Planning & Zoning Commission Regular Meeting

Wednesday, September 10, 2025 at 6:30 PM

- 1. Conduct the public hearing on a Subdivision Concept Plan for Manor Downs Industrial, being seven (7) lots on 146.920 acres, more or less, and being TCAD parcels 247972, 247974, 247987, 247986, 247984, 247973, 477389, 247991, also known as 8916 Hill Ln, Manor, TX.**
Applicant: Bowman Consulting Group, LTD
Owner: Tim Kraftson

The first submittal of the Manor Downs Concept plan (*Concept Plan*) submitted by BWMN and received on July 01, 2025, have been reviewed for compliance with the City of Manor Subdivision Ordinance 263B.

CONCEPT PLAN

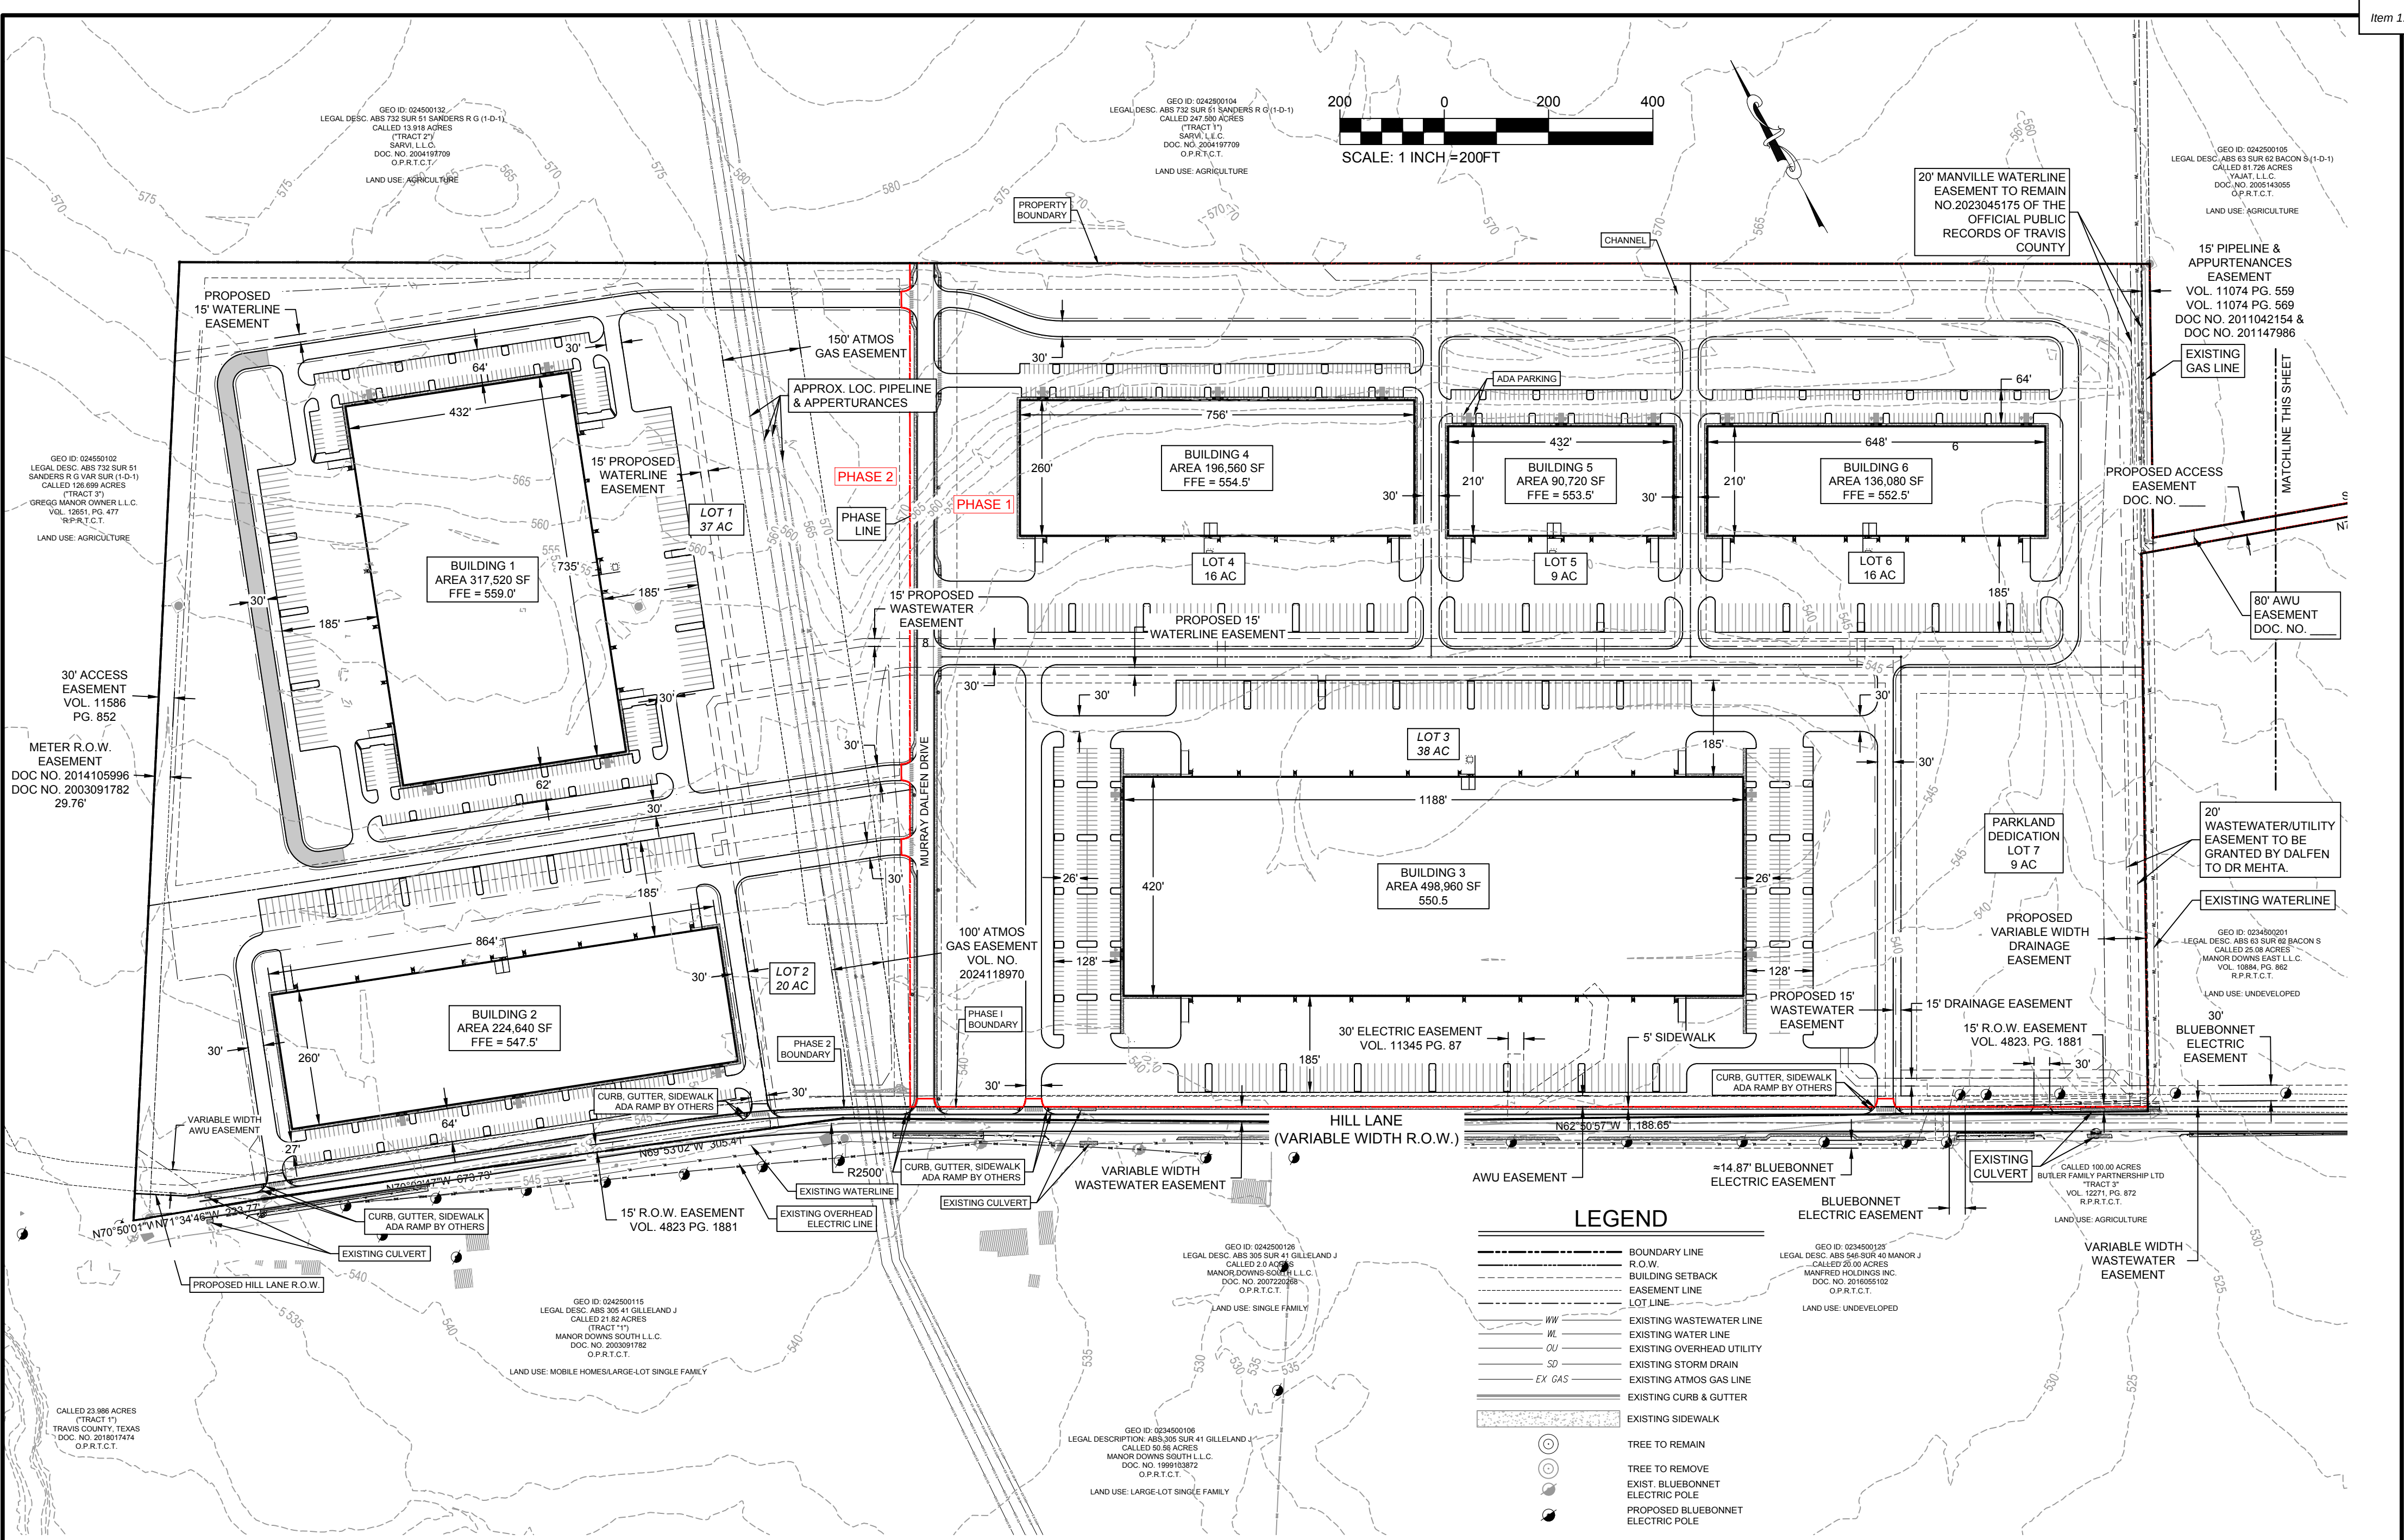
- i. ~~Adjust the landscape and architect contact information that overlaps the vicinity map.~~
 - ii. ~~Provide documentation that these parcels have been annexed into the City of Manor.~~

- iii. ~~Who will provide water and wastewater services to this site?~~
 - a. ~~Water is within Manville's CCN.~~
 - b. ~~Wastewater is within the City of Austin CNN.~~

- c. ~~Provide how many LUEs for wastewater are being proposed.~~
 - iv. ~~Call out any significant existing features on, or within 200 feet of, the property, such as railroads, roads, buildings, utilities, and drainage structures.~~

- a. ~~Existing buildings are on site.~~
 - v. ~~Will this project be broken down into multiple phases or just one phase?~~
 - a. ~~If applicable, provide approximate boundaries and anticipated timing of proposed phases of development and uses. List the proposed phases with estimated years of completion and what improvements will be in which phase.~~

6. ~~City of Manor acknowledgements signature blocks should be added to the Cover Sheet.~~

1. Adjust the landscape and architect contact information that overlaps the vicinity map.
Response: **The contact information has been moved out of the vicinity map.**

3. Who will provide water and wastewater services to this site?
 - a. Water is within Manville's CCN.
 - b. Wastewater is within the City of Austin CNN.**Response:** **Manville will be the water service provider. We have already kicked off conversations with Erik Prinz and Raul Ochoa at Manville about building a new public line throughout the site to service the development. Wastewater will be a mix of private force main, gravity wastewater, and a lift station on site. Once the wastewater leaves the property line, it will become public and connect to the FM alignment that Kimley Horn is designing for the City of Manor. This is per conversations had with the City of Manor and Pauline Gray.**

- a. Existing buildings are on site.**Response:** **The existing buildings onsite are to be demolished. Please see attached for the existing conditions and demolition plans for this site. These are being provided as separate exhibits because it crowds the concept plan.**

Response: **This project will be broken into two phases. The phase boundaries are shown on the concept plan. Phase 1 consists of the Subdivision (public roadway and waterline) and Site Plan A (industrial buildings plan east), and Phase 2 consists of Site Plan B (industrial buildings plan west). The anticipated timeline is as follows: Phase 1, Subdivision and Site Plan A, in August of 2025 and Site Plan B in December of 2028.**
